Subject: **Response to Portion of NRC Request for Additional Information Letter No. 344 Related to ESBWR Design Certification Application - Radiation Protection - RAI Number 12.4-19 S04**

**Response to Portion of NRC Request for  
Additional Information Letter No. 344  
Related to ESBWR Design Certification Application**

**RAI Number 12.4-19 S04**

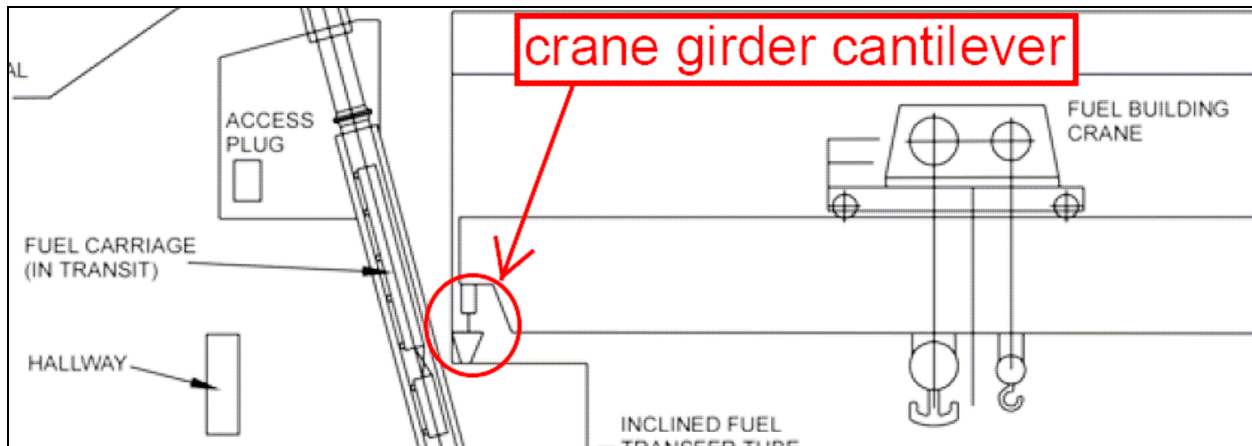
*c. GEH's response to item 10 states that the crane girder cantilever accounts for 75 cm of the 125 cm of concrete shielding assumed between the IFTT and room 2400 (at elevation 13570) in the Fuel Building. Provide a description of what is meant by the crane girder cantilever and describe its location on DCD Figure 9.1-2.*

The term “crane girder cantilever” refers to the wall mount attached to the girder that supports the fuel-building crane. A depiction has been provided below. The concrete crane girder cantilever is approximately 75 cm thick.
